NUCLEAR ENERGY INSTITUTE

SUBJECT: Response to Request for Additional Information, SEQUAL Topical Report, *Basis for Adoption of the Experience-Based Seismic Equipment Qualification Methodology by Non-A-46 Nuclear Power Plants*

PROJECT NUMBER: 689

NRC Issues and SEQUAL Responses

Figure 5-1

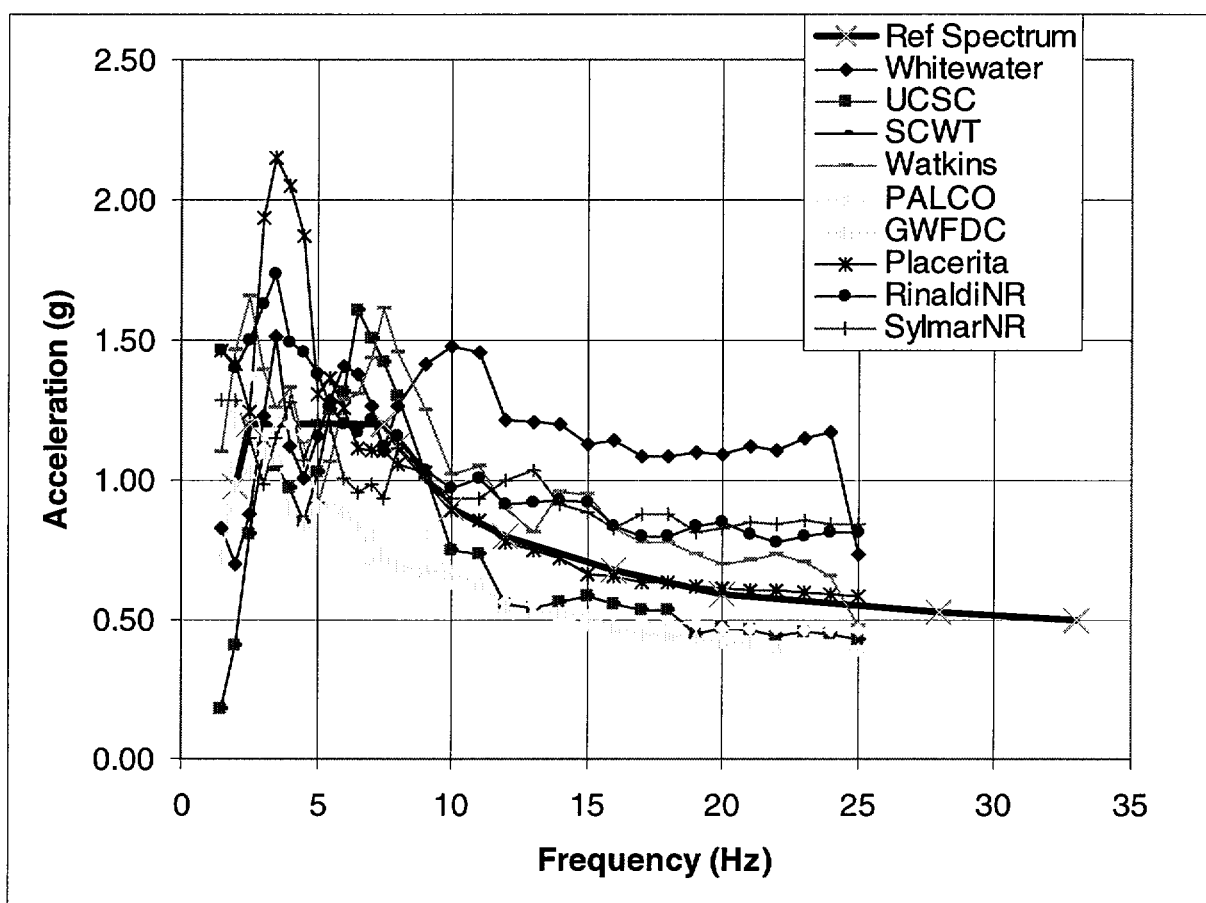
NRC's Request: Regarding the continued use of the GIP-2 reference spectrum to represent the seismic capacity of all of the equipment classes for EBSEQ, the staff requests that SEQUAL determine a unique seismic capacity spectrum for each equipment class using the equipment data from post 1985 earthquakes. The seismic capacity spectrum for each class should be determined using the proposed ASME QME methodology. In the event that each equipment class capacity spectrum entirely envelopes the GIP-2 reference spectrum, then the GIP-2 reference spectrum may continue to be used to represent the seismic capacity of all of the equipment classes for EBSEQ.

Description in August 13, 2001, Letter: The staff's fifth concern dealt with the adequacy of GIP-2 reference spectrum to represent the seismic capacity of all of the equipment in the earthquake experience database. The staff noted that it would be preferable if each class of equipment had its own unique seismic capacity spectrum rather than a single generic spectrum for all types of equipment. The staff further noted that each class of equipment should be sufficiently populated to provide reasonable assurance that the equipment in the class will function during and after an earthquake. In its response, SEQUAL justified the use of a single reference spectrum to represent the seismic capacity of all of the equipment in the database by stating that (1) the four response spectra used to develop the GIP-2 RS are from earthquakes whose magnitudes were greater than 6.0 and the estimated peak ground acceleration (PGA) at the four sites was greater than about 0.4g and (2) these four RS sites contained a "significant number of data base equipment in each of the equipment classes." In addition, SEQUAL showed in Appendix D of the Topical Report that the seismic capacity spectra it developed for each of the 20 classes are, in general, higher than the GIP-2 RS over the frequency range 2.5 - 7.5 Hz. SEQUAL developed these 20 seismic capacity spectra using the methodology "currently being considered for inclusion in industry standards for equipment seismic qualification." The staff notes that this proposed methodology for determining a seismic capacity spectrum (ASME QME) requires the use of 30 "independent items" for the determination of the equipment capacity spectrum. An independent item is defined in the proposed standard as "pieces of equipment that are not installed side by side in a facility, and are neither identical, nor identically mounted or supported." The staff concludes that the 20 equipment capacity spectra developed in Appendix D of the Topical Report are only loosely assumed to be from independent equipment items since SEQUAL stated, "estimates of the number of independent items were made based on kind of equipment normally found in the type of facility." It is therefore unlikely that the 20 seismic capacity spectra developed by SEQUAL in Appendix D of the Topical Report meet the proposed ASME QME provisions for the development of earthquake experience spectrum (EES). The staff also notes that the EES, shown in Appendix D of the Topical Report, do not follow the proposed ASME QME standard since they are truncated at an average value between 2.5 - 7.5 Hz, which may result in an unconservative estimate of the equipment capacity. To meet the level of seismic qualification of equipment, which is comparable to the level of qualification required by Part 100, requires a more accurate representation of the seismic capacity of equipment than that provided by the GIP-2 RS. An EES for each of the equipment classes, which meets the requirements set forth in the proposed ASME QME standard, would provide a more accurate representation of the equipment seismic capacity. Alternatively, SEQUAL could use a single spectrum to define the equipment capacity that falls below the lowest EES determined for each of the equipment classes.

The second basis for concluding that the Reference Spectrum accurately represents the seismic capacity of the earthquake experience equipment classes is that, since 1987, when the NRC staff reached the above conclusions, SQUG has continued to evaluate the results of significant earthquakes around the world. The results of these reviews show that no equipment damage has been discovered that would require changes to the current GIP class definitions (inclusion rules) and restrictions (caveats). The facilities investigated by SQUG included those that experienced large earthquakes (magnitude $M_w \geq 6.0$) with ground motions equivalent to those used in 1985 to develop the Reference Spectrum. Such earthquake/facility pairs include those listed in Table 5-1 below. SEQUAL is considering including this table and a plot of the ground response spectra for these facilities compared to the Reference Spectrum (see Figure 5-1 below) in the revised Topical Report.
